CD-2023-264

**Subject: Federal Cell Facility Application: Responses to the Director's Request for Information –
DRC-2023-078530**

Appendix B: Federal I Cell Facility Engineering Drawings

14004
 C02

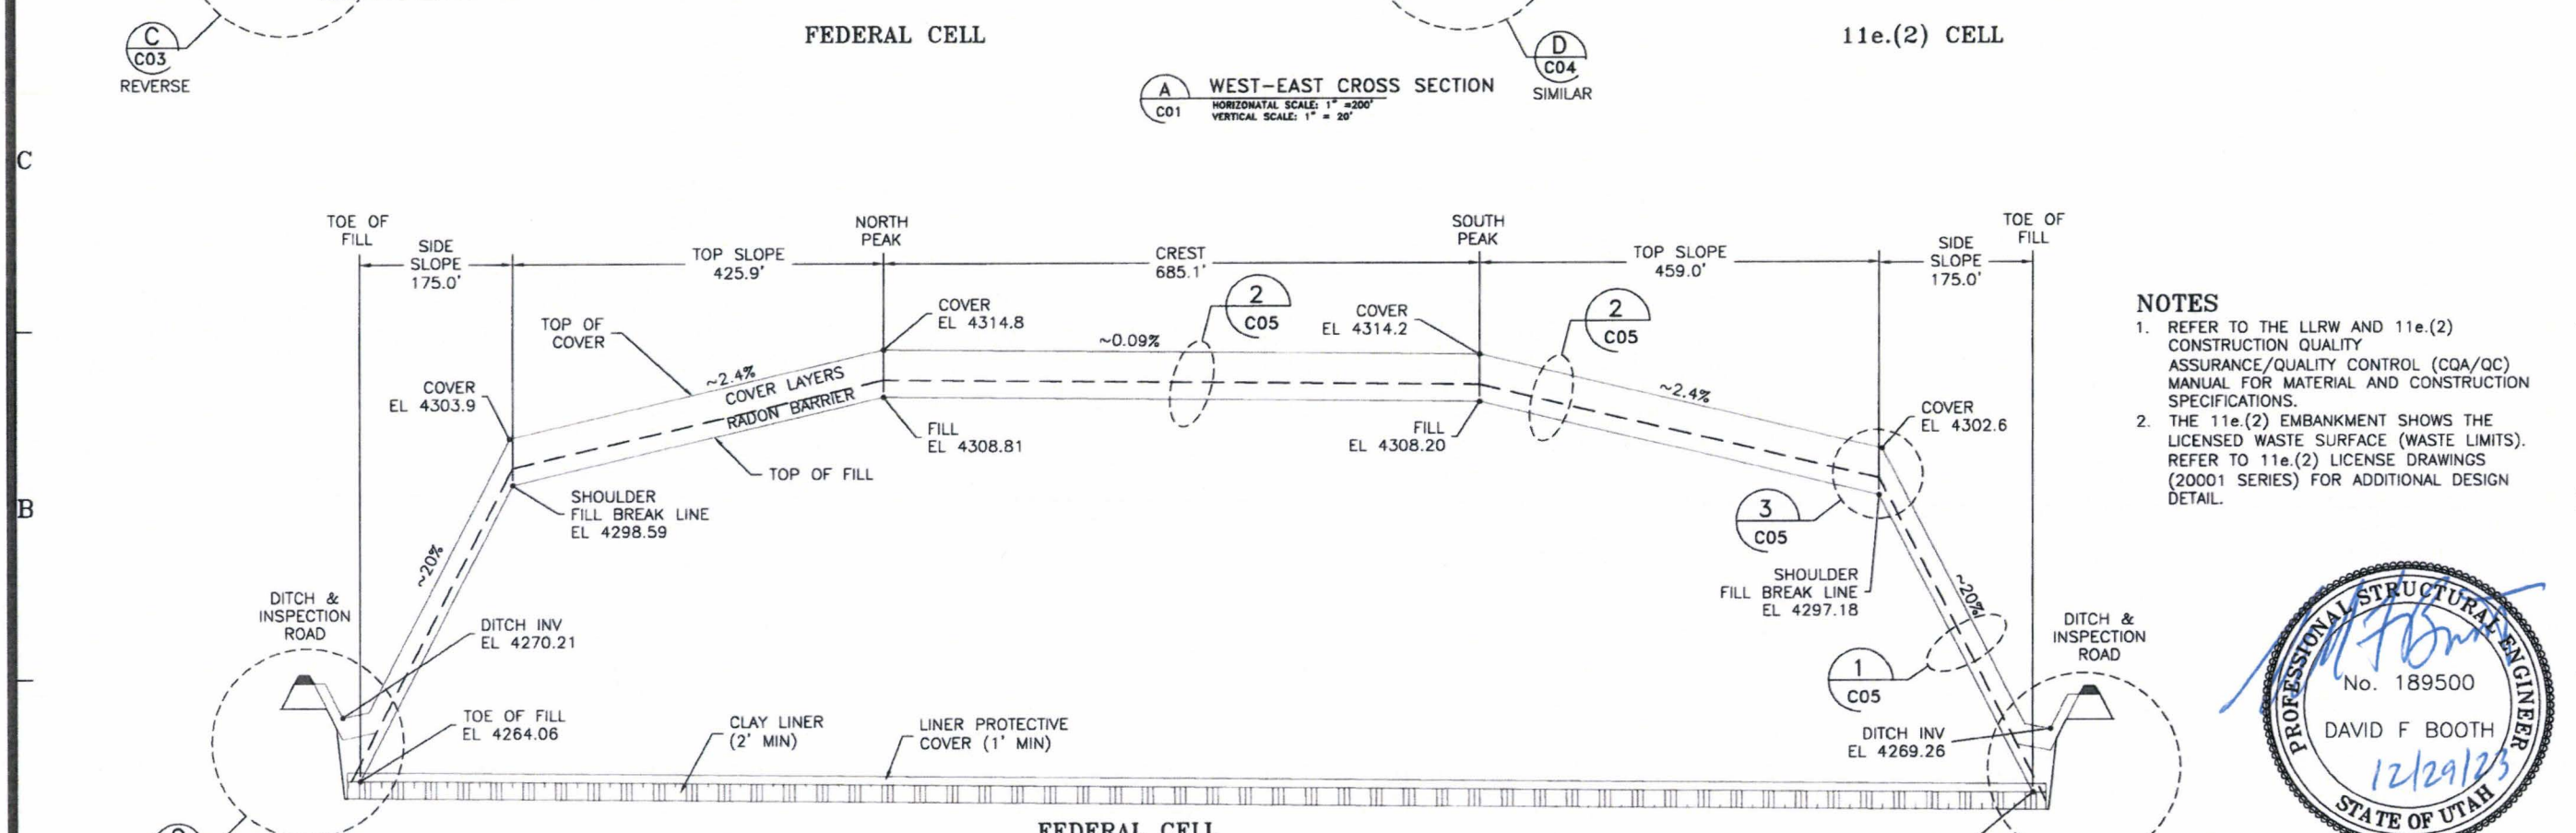
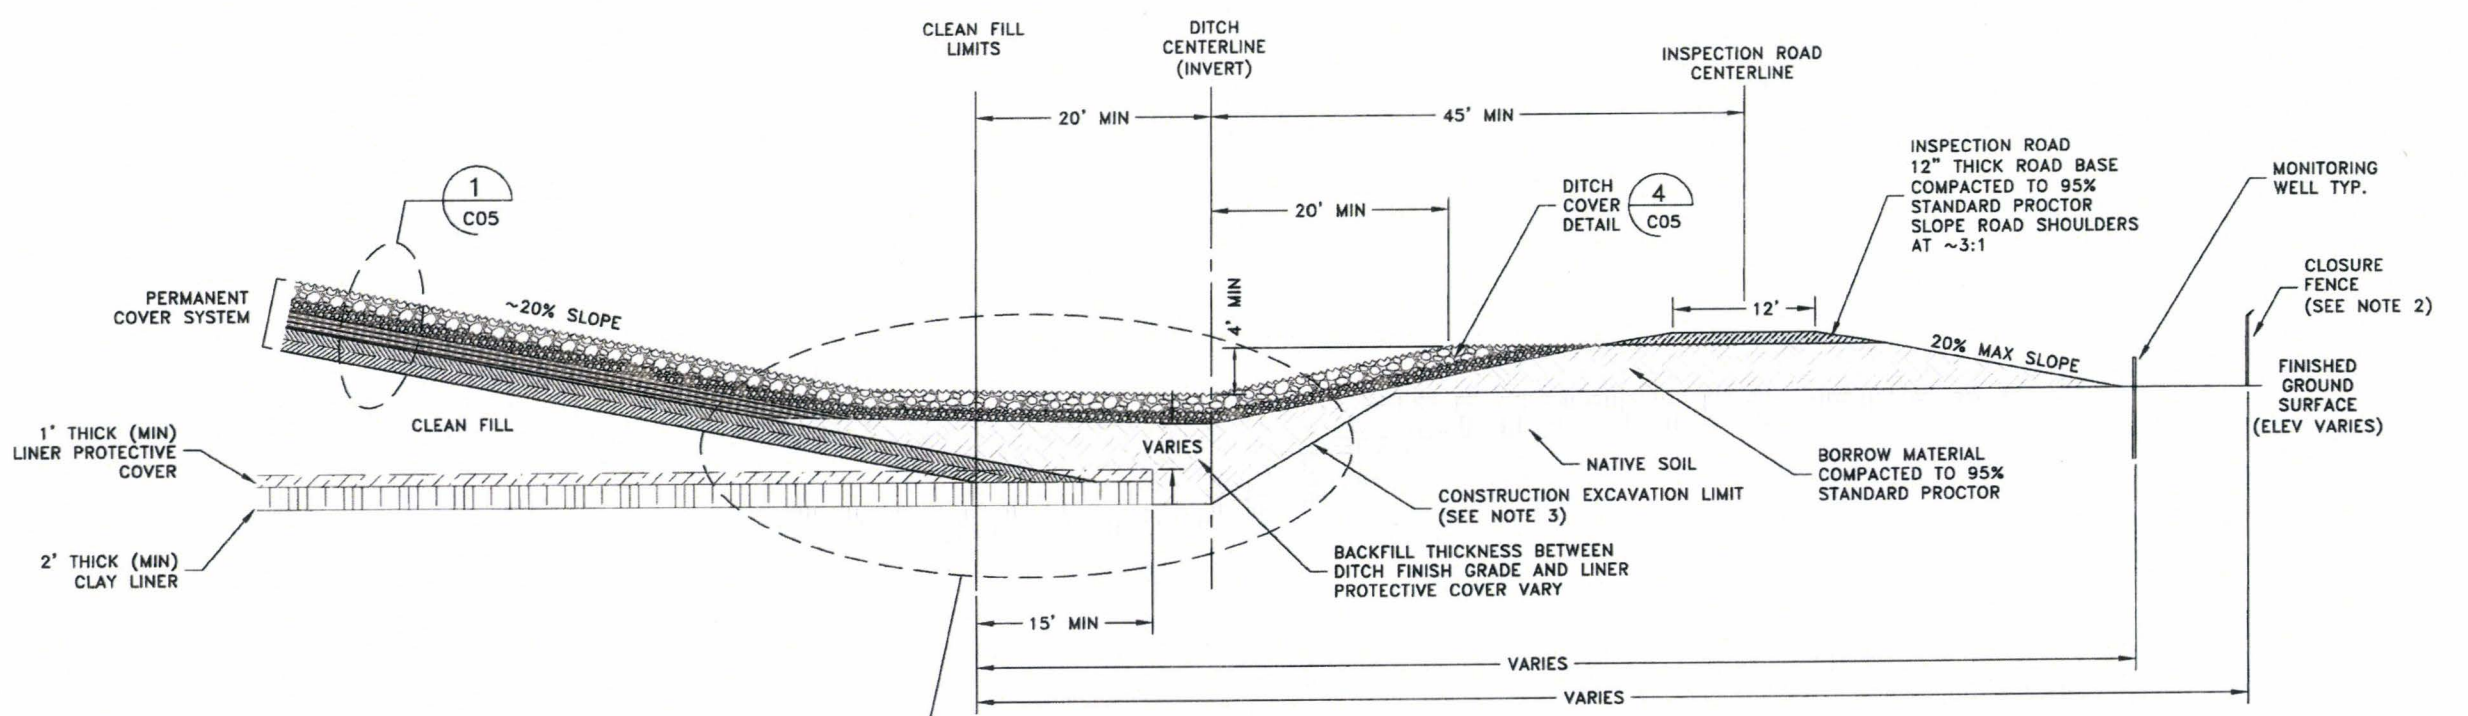
B-12: Crest length of 685.1' and approx. slope depicted in cross section B of sheet 14004-C02 is not delineated on this plan.

B-25: *Slopes are assumed to be approximated in other areas of these drawings. Why is this dimension considered to be not approximate? Please review RFI B-18 and consider consistent dimensions precision throughout these drawings.*

B-26: *It is assumed that the overall approximated geometry of the Top of Waste correlates to Note (5) of Sheet 14004-C01. Please provide clarity on this sheet (14004-C02) reiterating that statement with consideration of RFI B-18.*

B-27: Ditch invert measures to be a high point in between the Northeast corner invert and Southeastern corner invert. Please clarify or revise the dimensions with consideration of RFI B-18.

B-31: Section view indicates North is to the left and South is to the right. Please revise title of section or reorient the section and associated callouts.

The crest length and slope notations have been added to Engineering Drawing 14004-C02.

The precision noted on Engineering Drawing 14004-C02 has been revised.

The correlation of the Top of Waste notation has been expanded and the precision adjusted on Engineering Drawing 14004-C02 has been revised.

The Ditch measurements in between the Northeast and Southeastern corners has been revised and the precision adjusted on Engineering Drawing 14004-C02.

Section title on Engineering Drawing 14004-C02 has been revised.

DESIGNED BY	D. BOOTH
CHECKED BY	N. CLARKE
APPROVED BY	D. BOOTH
DATE	01/13/20
PROJECT NO.	14004 C03

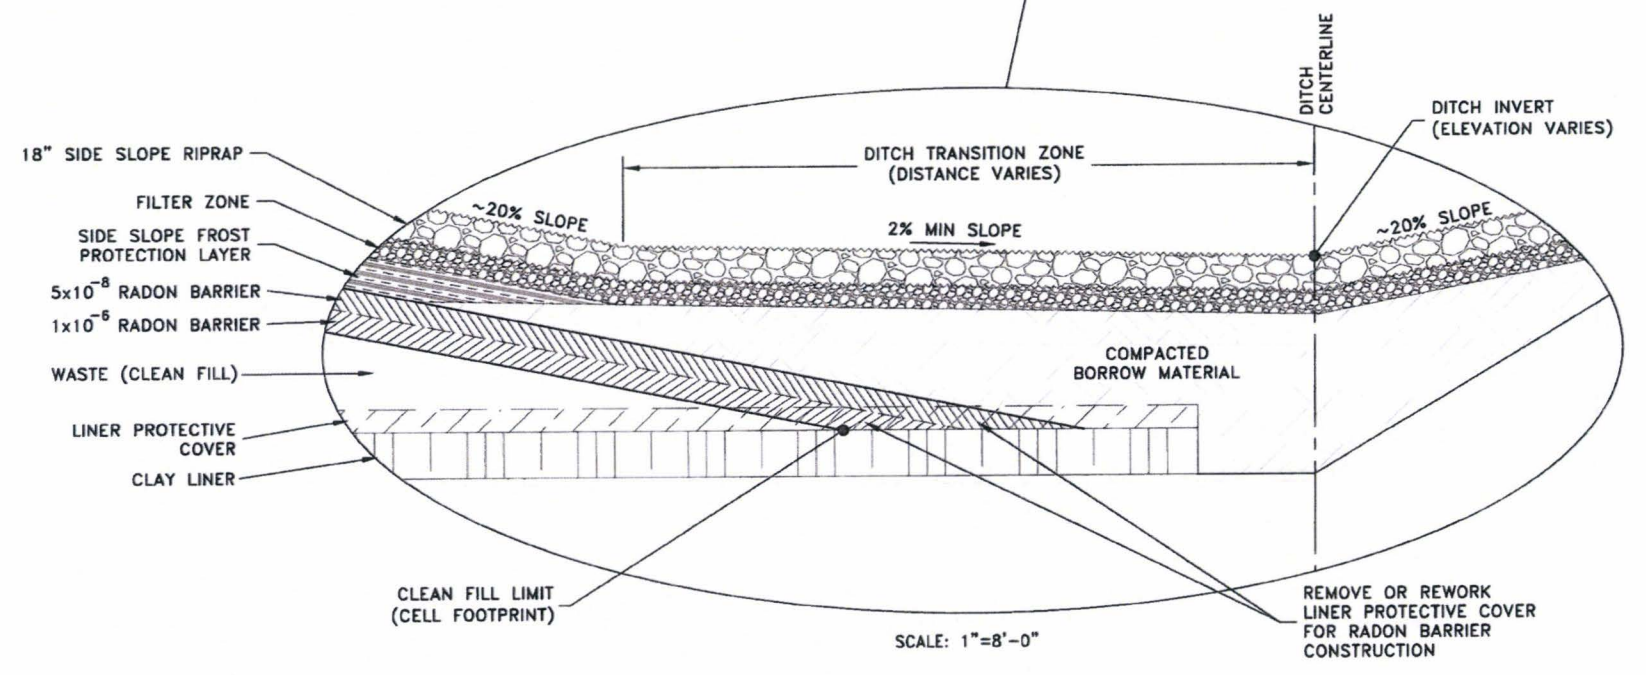
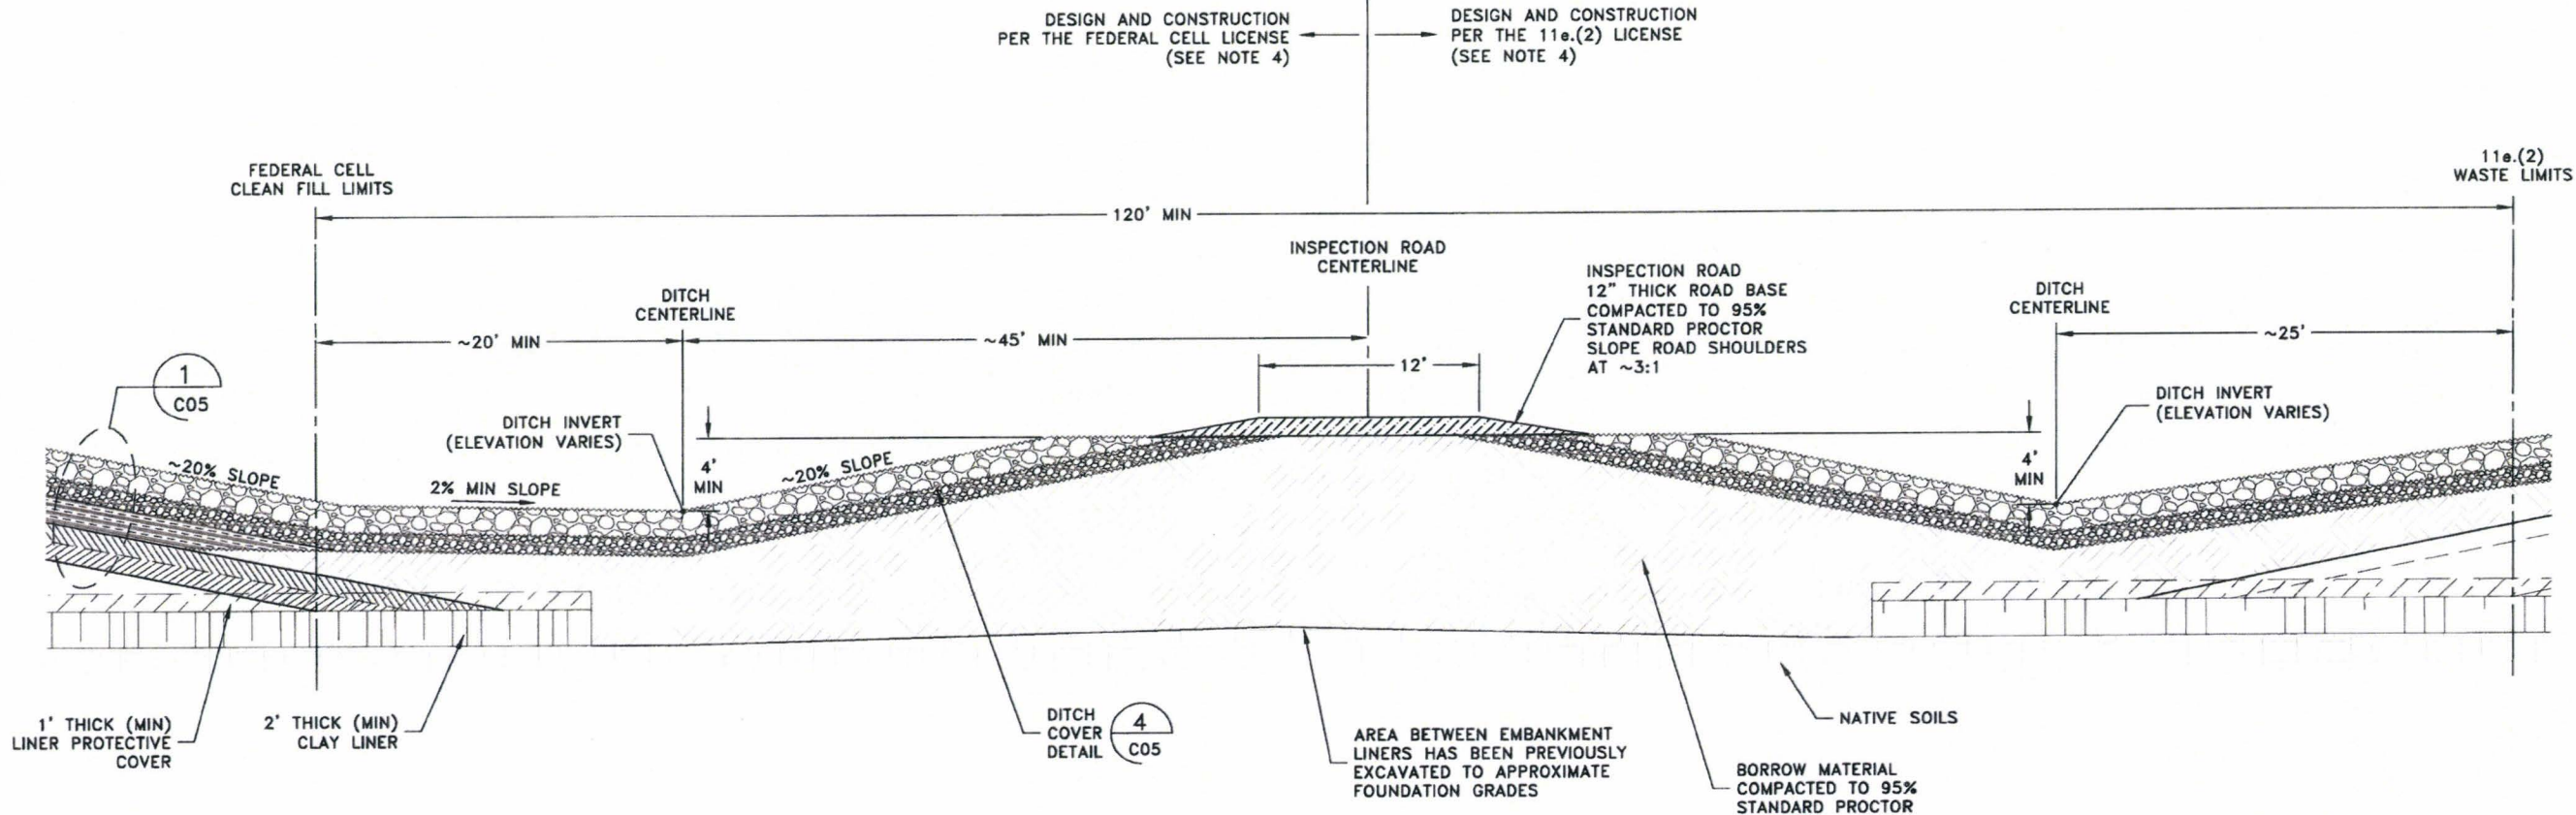
B-33: It is unclear as to what dimension varies here. Are the Clay Liner and Liner Protective Cover the varying dimension keying into existing grade? Are these dimensions generally unknown? Please elaborate or provide notes on this sheet.

B-37: *Please maintain consistent dimension call out with Detail C on Sheet 14004-C03.*

B-38: *Detail C on Sheet 14004-C03 notes a minimum distance of 45’ from Ditch Centerline to Road Centerline. This suggests there should be a minimum distance required between the Ditch Centerline and the Inspection Road Centerline. If that is a correct assumption, a minimum criterion should be established here.*

B-39: *Has grading the “shoulder” of these inspection roads to slope towards the ditches been considered? This cross section and other details have exhibited a visual of a slope. Please provide detail on the dimensions of these slopes to better visualize and understand the intent of a 12” raised roadway from “borrow material.”*

B-40: *Is there an assumption that all the material between the existing 11e.(2) embankment and the proposed footprint of the Federal Cell must be excavated to the edges of Clay Liner? There is no true delineation of what currently exists and how EnergySolutions intends to tie into existing conditions. Please provide information to clarify.*

Engineering Drawing 14004-C03 has been revised to clarify the dimensional key ins.

The dimensions on Engineering Drawing 14004-C03 have been revised.

The ditch and inspection road dimensions have been clarified and expanded on Engineering Drawing 14004-C03.

The dimensional detail for inspection road slopes has been revised and expanded on Engineering Drawing 14004-C03.

The existing conditions between the existing 11e.(2) embankment and proposed Federal Cell Facility have been clarified and expanded on Engineering Drawing 14004-C03.

14004
 C04

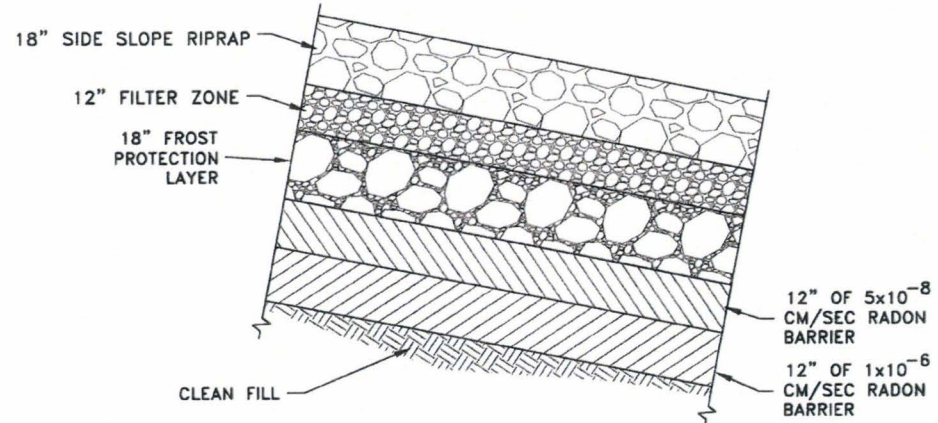
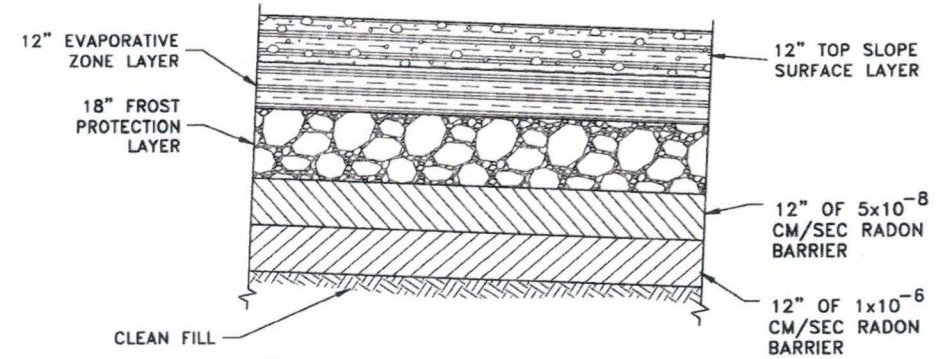
B-41: *Note (5) of sheet 14004-C01 should be reiterated on this sheet to provide clarity that the 11e.(2) dimensions displayed herein are approximated and will be clarified in the 11e.(2) License Drawings. Additionally, please see RFI B-18.*

B-43: *The limits of construction that are under the 11e.(2) license and the Federal Cell license are not clearly defined in this cross section. Please provide clarity if the road and ditches between the cells are part of their respective licenses and/or showcase the delineation within this plan set.*

The detail of 11e.(2) dimensions and its present-day completeness are the subject of Radioactive Material License UT2300478 and independent of the Federal Cell Facility Radioactive Material License Application. The process and timing for closure of the 11e.(2) embankment is solely governed by conditions in License UT2300478. If approved, construction and operation of the proposed Federal Cell Facility will proceed in accordance with the license granted in response to that Application and will similarly be independent of operation or closure of the 11e.(2) embankment. Even so, Note (5) from Engineering Drawing 14004-C01 has been repeated on Engineering Drawing 14004-C04 in response to the director’s preference.

The limits of construction between the 11e.(2) and Federal Cell Facility have been clarified on Engineering Drawing 14004-C04.
